In re Application of )  
 )  
**PANUNTO, John P.** )  
 )  
Serial No: 10/660,533 ) Art Unit: 3653  
 )  
Filed: 09/12/2003 ) Examiner: **MORRISON, Thomas A.**

For: **LARGE CAPACITY BOTTOM FEED DISPENSER**

**RESPONSE TO OFFICE ACTION DATED 01/03/2006**

Fig. 3

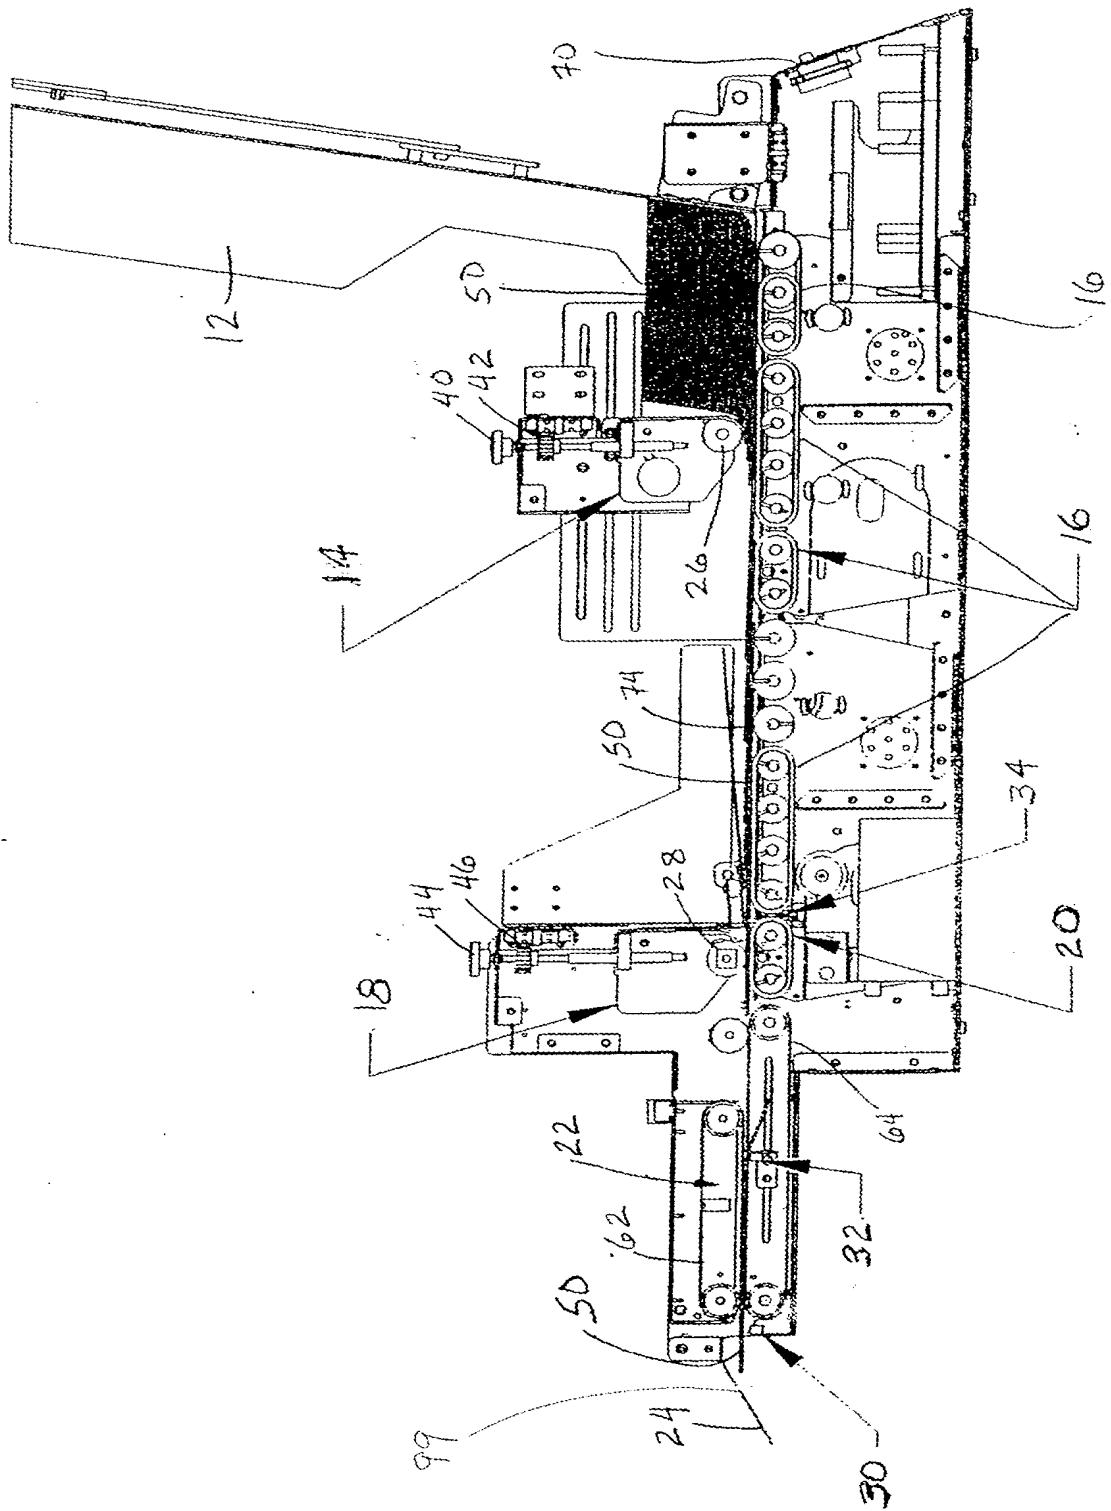
The attached sheet of drawings includes changes to Figure 3. This sheet replaces original Figure 3.

The drawings were objected to because of the reasons set forth in section 1 of the Office Action. In response, Figure 3 has been amended to remove reference character 22 pointing to the axle of the transport conveyor. Figure 3 has also been amended to label the location of the box ready sensor 99. In a related amendment, paragraph [0054] has been amended to identify the “box ready sensor” as --box ready sensor 99--. In view of these amendments, it is respectfully submitted that the drawings are now in proper form, and withdrawal of the objection to the drawings is requested.
